Subject: HPRM: FW: Revision 1: Lendlease Submission Re : Planning Agreement- 1 Alfred Street, Sydney, NSW 2000: Wanda One Sydney P/L. Additional text to Item 3 Shared Basement. Wanda basement entry.

Subject: Lendlease Submission Re : Planning Agreement- 1 Alfred Street, Sydney, NSW 2000: Wanda One Sydney P/L

We refer to the City's Notification letter dated Nov 29, 2016 Re: Planning Agreement Reference : D2016/1529, D2015/1049 and D 2015/882 (**Draft Wanda VPA**)

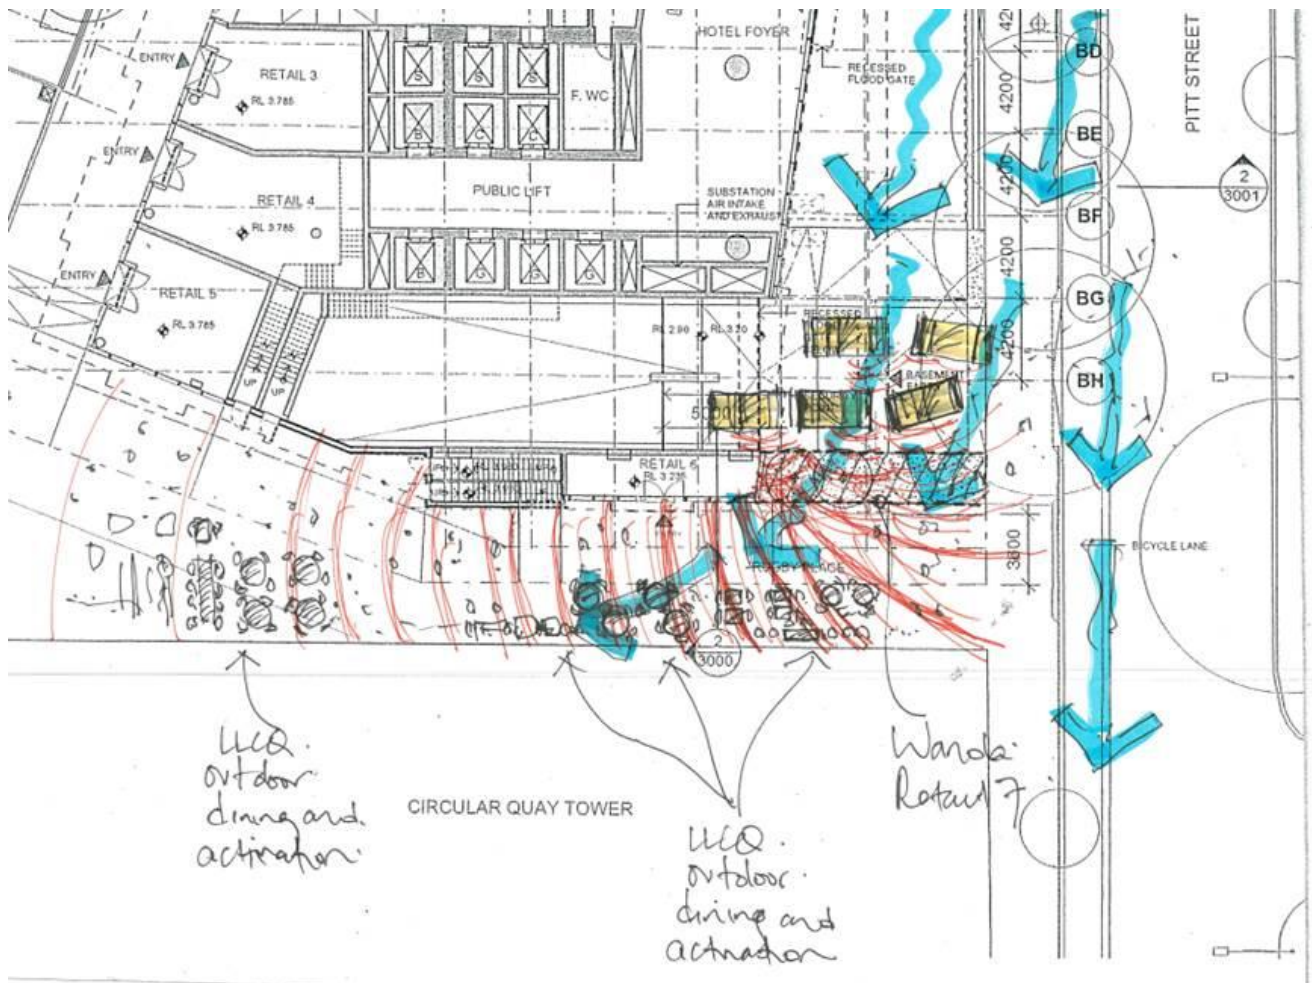
As noted in my original submission below, and as discussed yesterday, the circa **13m Pitt Street setback** of the Wanda Hotel at the south eastern corner at the ground level is of concern to the future amenity of the City's pedestrianised Rugby Place laneway because the laneway is unscreened from vehicular emissions (noise, vibration and exhaust fumes) generated by those cars using the Wanda basement entry/exit.

The low level landscape proposed by Wanda will likely be in effectual in addressing these negative environmental impacts within the City's new laneway.

This condition will be further exacerbated by the predominately north easterly winds entering Pitt Street during the warmer Sydney months (Refer Wanda's own Wind Report prepared by CCP). Refer the arrows in blue in my sketch.

In addition, further potential laneway activation through additional Wanda retail is lost because of the Hotel buildings significant setback at the lane level.

As discussed, we would recommend Wanda consider additional retail (**Retail 7** as indicated on the sketch below and attached), the impact of which would be to:

1. Screen and preserve the amenity of the new Rugby Place pedestrianised laneway (including the future planned LLCQ outdoor dining opportunities) from the vehicular noise, vibration and exhaust emissions arising from the Wanda basement access
2. Better activate the new Rugby Place pedestrianised laneway with additional lanes development as part of the Wanda development
3. Provide Wanda with additional retail amenity and revenue streams

- Peak Flood Depths and Levels Ultimate Design Scenario (Sydney One and LL Developments) 100 year ARI Design Event- 47747-00
- Peak Flood Depths and Levels Ultimate Design Scenario (Sydney One and LL Developments) PMF Design Event - 247747-00

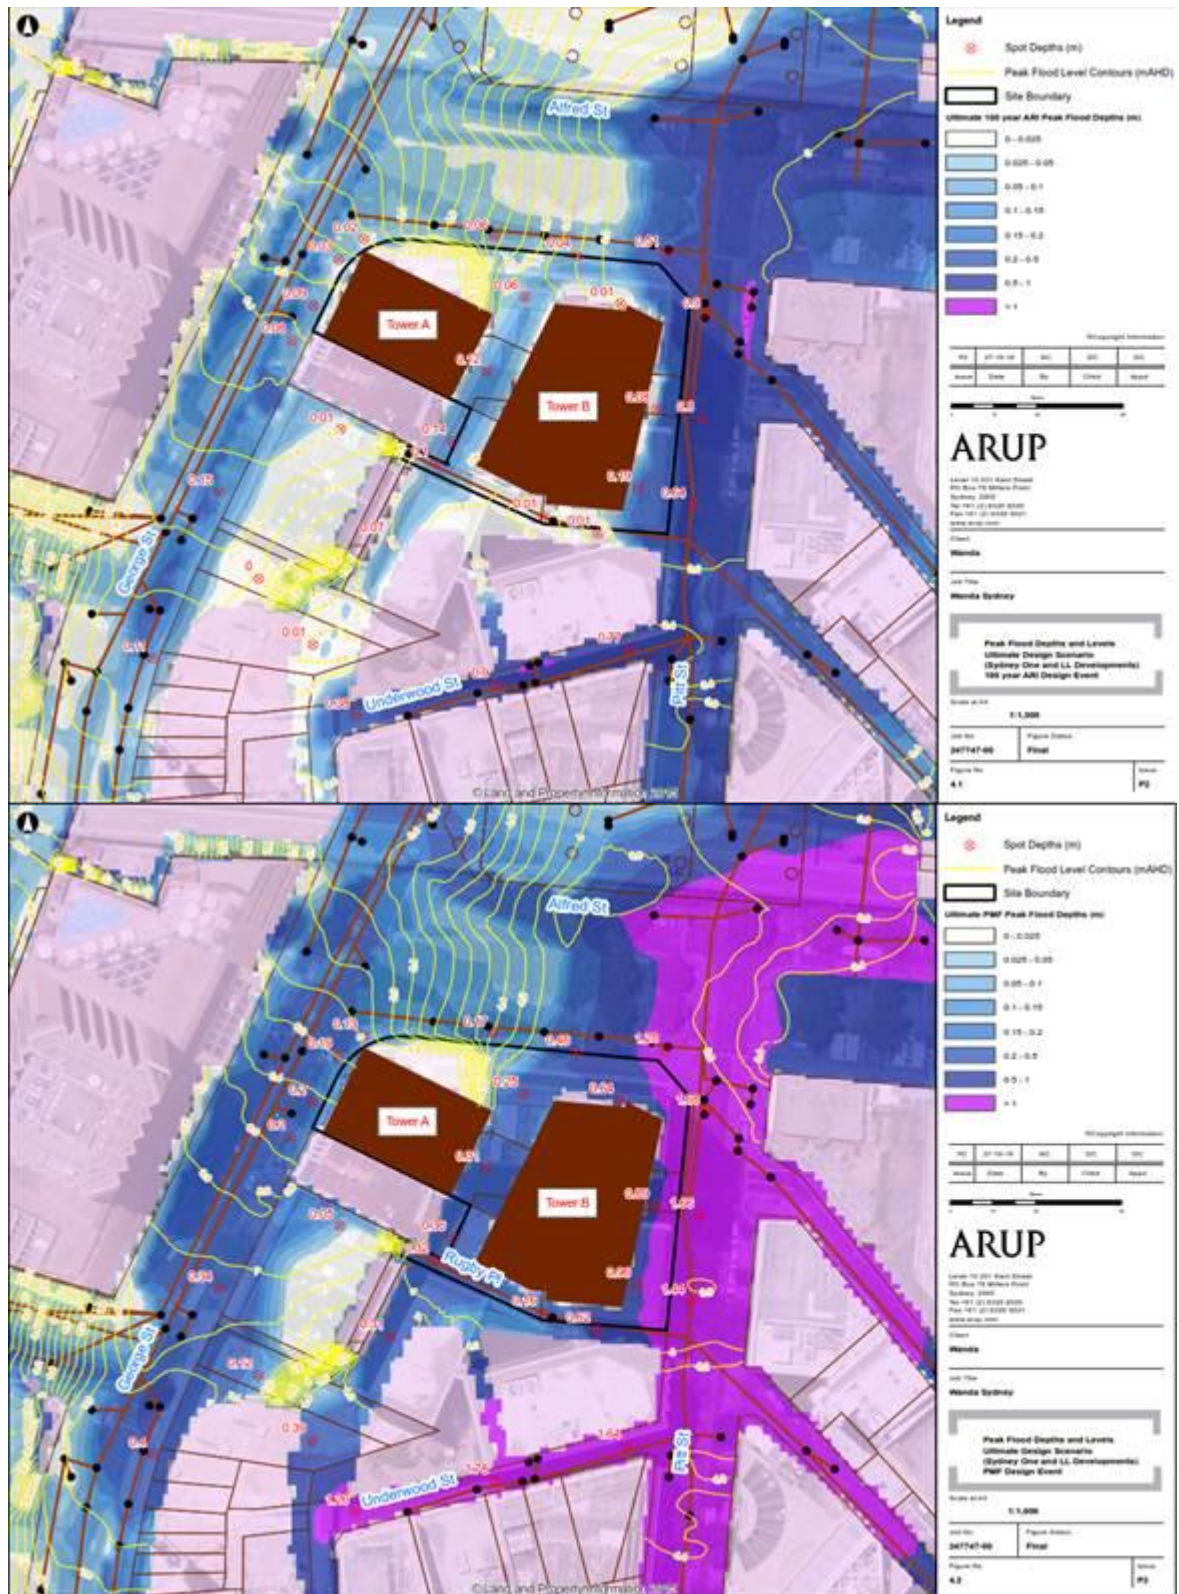
The Draft Wanda VPA does not contemplate the passing of flood water (and other storm water) from portions of the LLCQ site (to be ultimately dedicated to the City) across the Wanda site. The LLCQ site will ultimately encompass both Crane Lane and Mirvac Triangle.

Lendlease recommends that the Draft Wanda VPA be amended to provide for appropriate rights/easements permitting the conveyance of flood water (and other storm water, runoff etc) from the LLCQ site, including Crane Lane and Mirvac Triangle which will ultimately for part of the LLCQ combined site, (to be ultimately dedicated to the City), across the Wanda site to the extent as indicated on the following Wanda prepared Development Application Flood maps and as generally contemplated in the Wanda Development Applications:

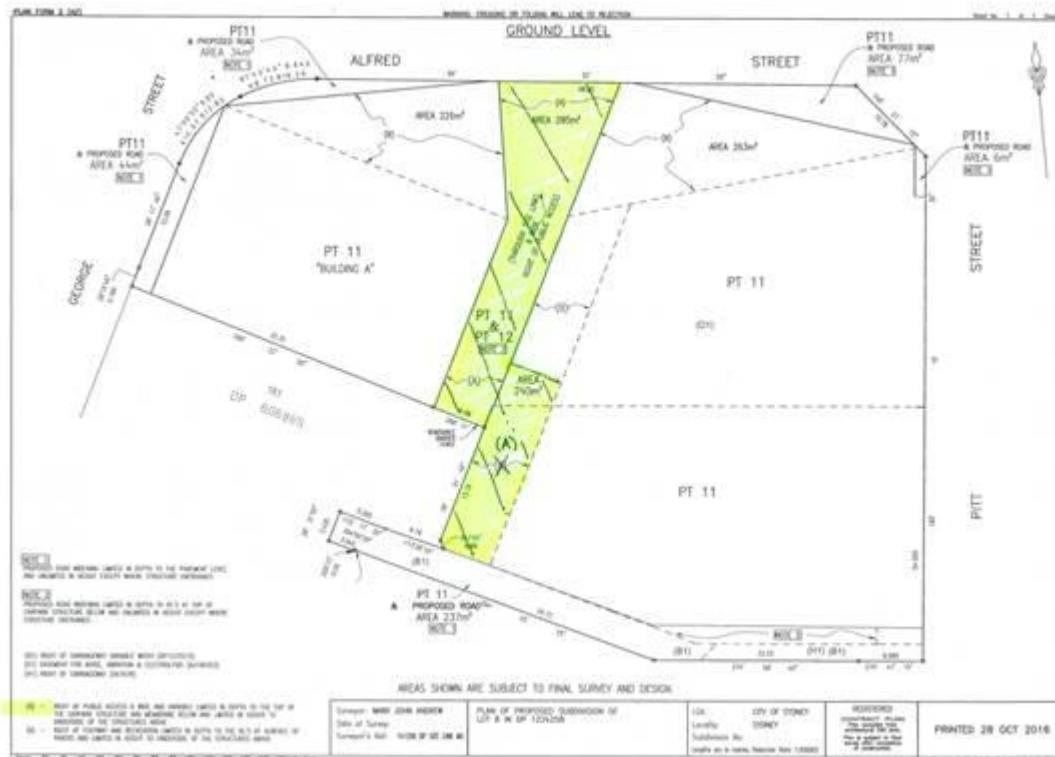
Lendlease believes that as proposed by Wanda in the Draft VPA, the configuration of (A) and (B) has the potential to limit the future outdoor dining areas to the laneway level retail proposed beneath Jacksons on George as part of the LLCQ endorsed Planning Proposal Scheme.

Lendlease has marked below what it believes is a more appropriate distribution between (A) and (B) that does not prejudice the future outdoor dining opportunities associated with the LLCQ retail described above, however would like the opportunity to discuss further with both Wanda and the City.

Lendlease asks that Council give consideration to the Lendlease proposal as noted above and indicated below and seeks the opportunity to consult prior to finalisation of the Wanda VPA.

8. Notes A or B per Wanda VPA Plans in Annexures E and F

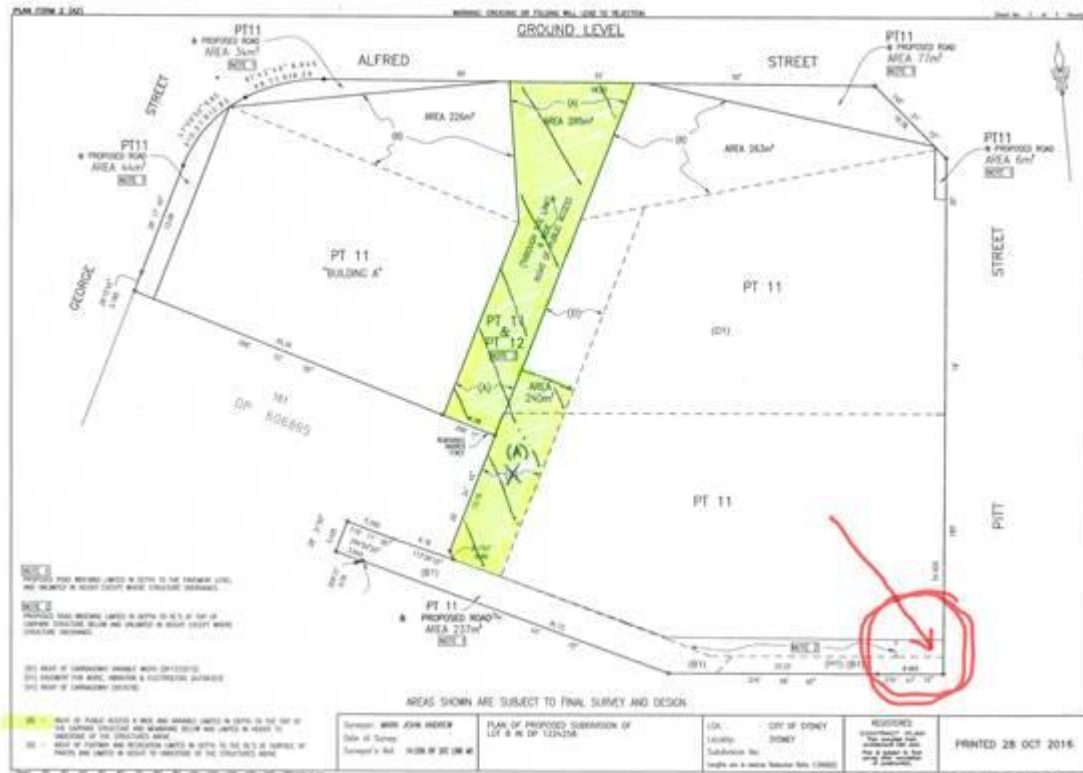
Notes A and B shown on the Wanda VPA Plans in Annexures E and F should also apply to the extent of the Wanda plan denoted as Note 2, in the event the extent of Note 2 does not form part of the 237 sq m of Proposed Road
